TVA-SQN-TS-02-01

SEQUOYAH NUCLEAR PLANT (SQN) - UNITS 1 AND 2 - TECHNICAL SPECIFICATION (TS) CHANGE NO. 02-01 - NOMINAL TRIP SETPOINTS FOR REACTOR PROTECTION SYSTEM (RPS) AND ENGINEERED SAFETY FEATURES (ESF) INSTRUMENTATION AND RELOCATION OF LOSS OF POWER AND RADIATION MONITORING INSTRUMENTATION REQUIREMENTS

PROPOSED TECHNICAL SPECIFICATION (TS) CHANGE TS 02-01 DESCRIPTION AND EVALUATION OF THE PROPOSED CHANGE

PROPOSED TECHNICAL SPECIFICATION (TS) CHANGE TS 02-01
MARKED PAGES

FIGURE 3.4-4

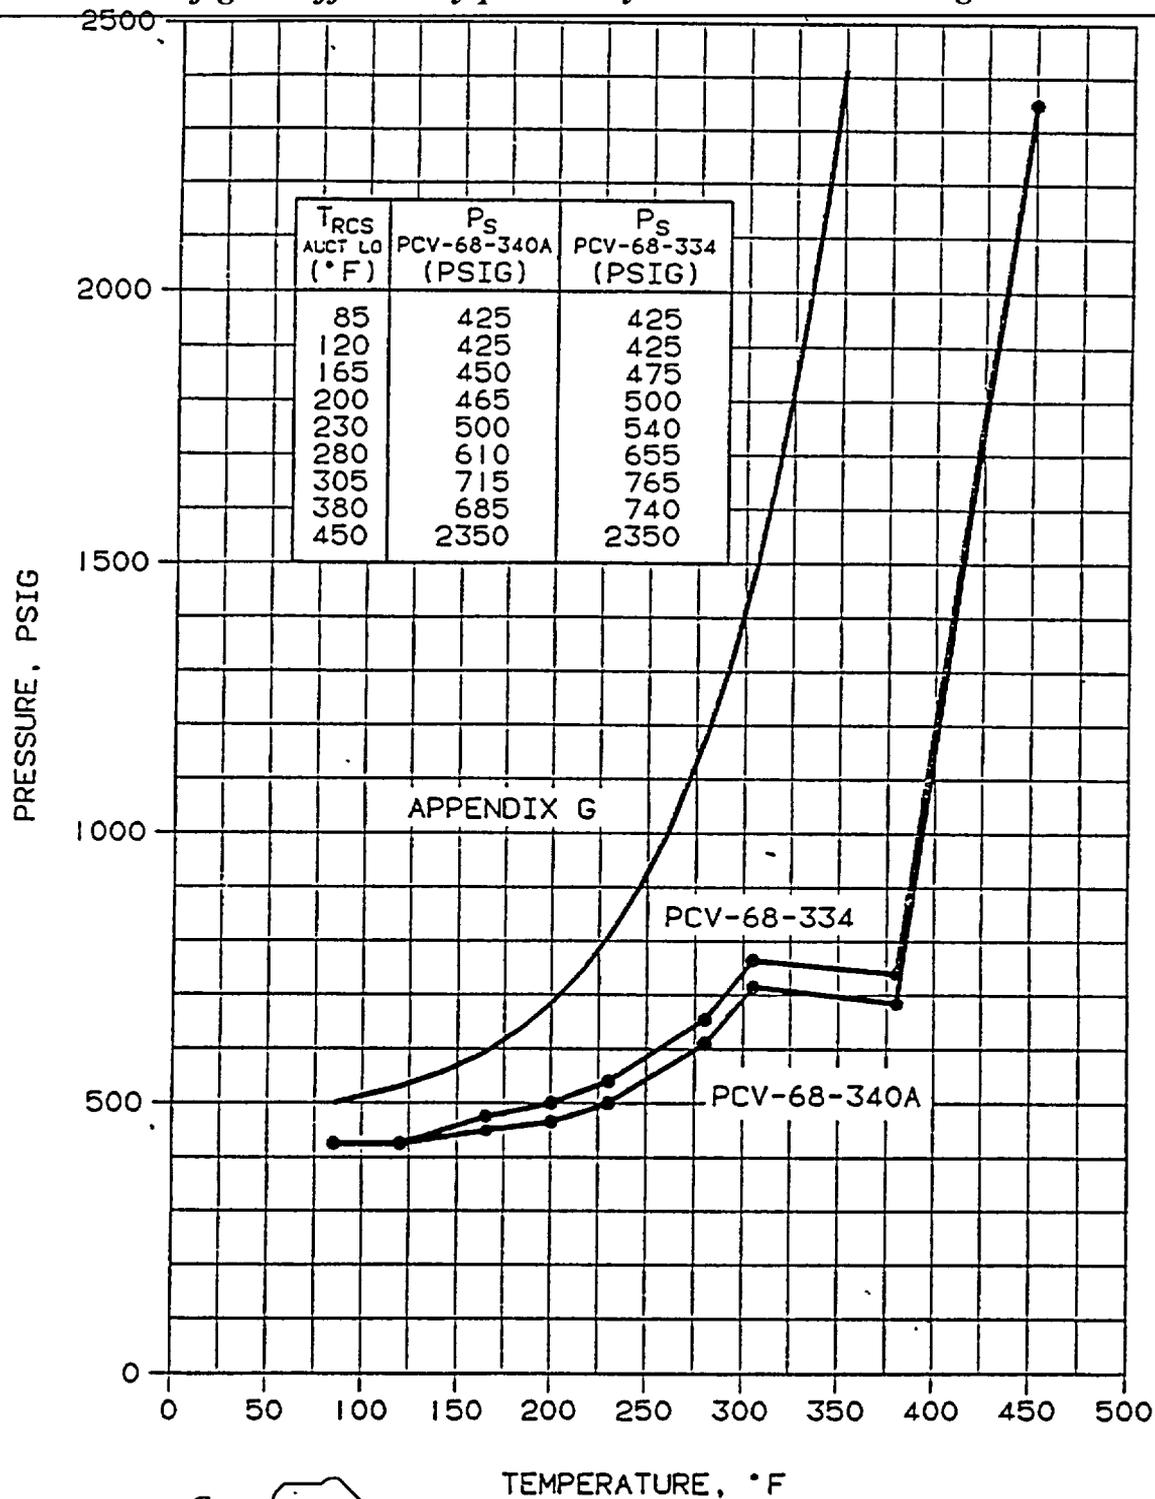
The proposed TS change will rename the Trip Setpoint column of TS Tables 2.2-1 and 3.3-4, remove the inequality signs for the trip setpoint values as appropriate, and revise the inequality representation for the allowable values (Avs) as needed. The new title for the Trip Setpoint column will be Nominal Trip Setpoint. Bases discussions clarify operable conditions for the functions and prescribe conditions where the setpoints may be set more conservatively. This revision also includes the revision of other locations in the TSs that currently use the term "trip setpoint" and need to be changed to "nominal trip setpoint" to be consistent with the table title. The Bases have been revised as necessary to support these changes. The term "nominal" will be removed from the average temperature at rated thermal power (T') definition in Table 2.2-1, Note 1 and from the lift setting requirement in Section 3.4.12 and the associated Figure 3.4-4.

- a. Two power operated relief valves (PORVs) with a nominal lift setting less than or equal to that shown in Figure 3.4-4, or
- b. The Reactor Coolant System (RCS) depressurized with an RCS vent of greater than or equal to 3 square inches

FIGURE 3.4-4

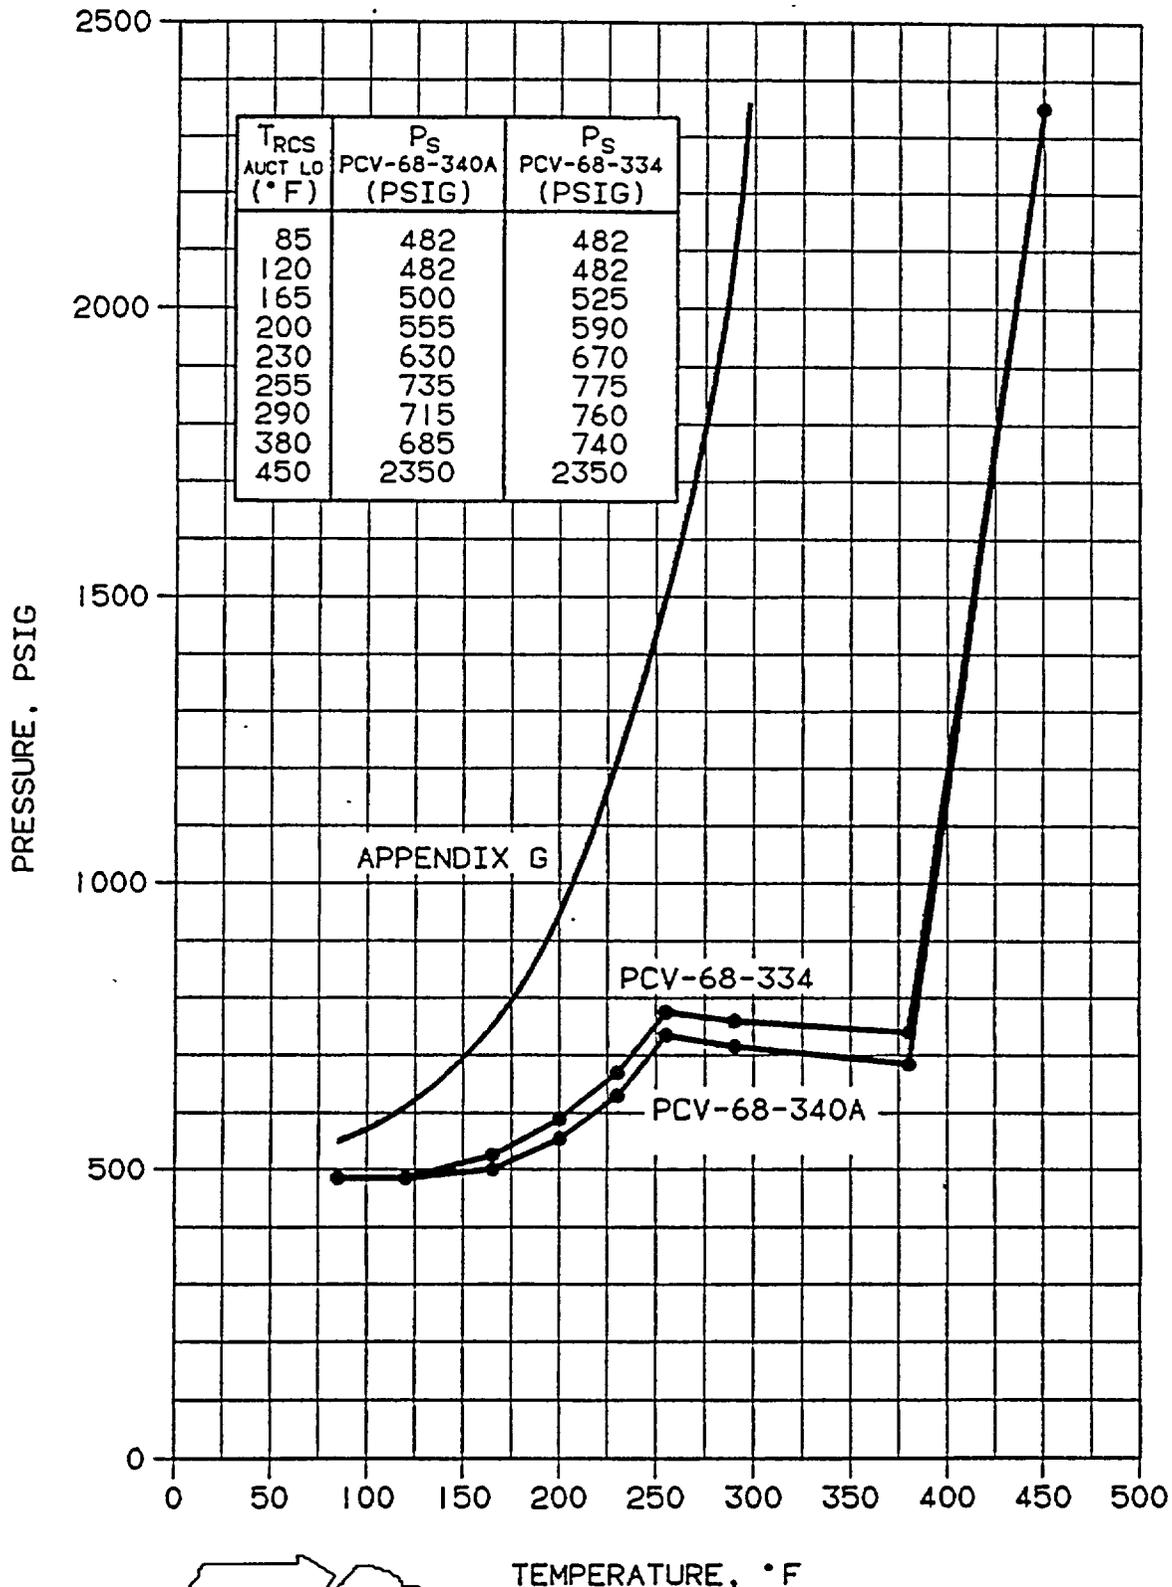
- a. Two power operated relief valves (PORVs) with a nominal lift setting less than or equal to that shown in Figure 3.4-4, or
- b. The Reactor Coolant System (RCS) depressurized with an RCS vent of greater than or equal to 3 square inches.
